## ROOF INSPECTION REPORT

INDIAN ROAD.  
TORONTO.

MARCH 31 2026

002

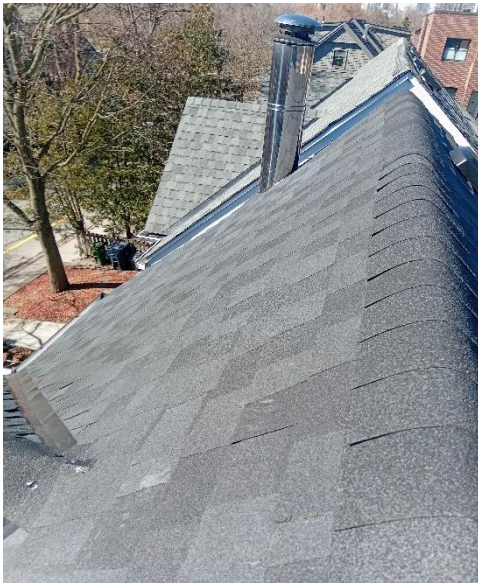
Image 002. Heat stack close-up. The stack is sealed at the shingles with caulking or a mastic product. Neither of these materials will survive over time. A heat stack must be sent through a 'cone and storm collar' fitting to isolate the stack from combustible materials such as shingles, as required by the Ontario Building Code.

Sound except for the lack of a 'cone and storm collar' fitting at the heat stack. Said fitting is a requirement.

FLAT ROOF OVERVIEW and rear shingle slop.

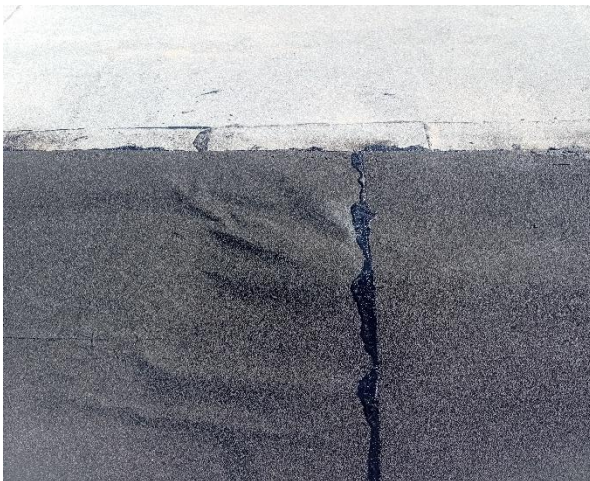
- 1) Images below. The membrane exhibits numerous wrinkles. These show that the membrane was not fully adhered to the substrate material and demonstrates sloppy workmanship by inexperienced labour. The images also show an excessive 'asphalt bleed' of 1" and up where a bleed of no more than ¼" is mandated. Excessive 'bleed' and a lack of embedded granules on the underlying membrane compromises the integrity of the seam. The lack of a bleed shows under heating. The seams' waterproofing ability is therefore compromised.

NOTE. Images 003 and 004 also show that the adjacent membrane had its' surface granules burnt and the granules not embedded prior to receiving the new membrane. The 'embedding' of granules of the substrate membrane is a requirement of the IKO membrane manufactures installation guide and standard roofing practice. This circumstance is common at all such details over the entire roof system.

This installation demonstrates poor workmanship by inexperienced installers, does not comply with the Manufacturers Installation guide nor the CRCA (Canadian Roofing Contractors Association) specifications for modified bitumen roof installation and standard roofing practice. It should be replaced.
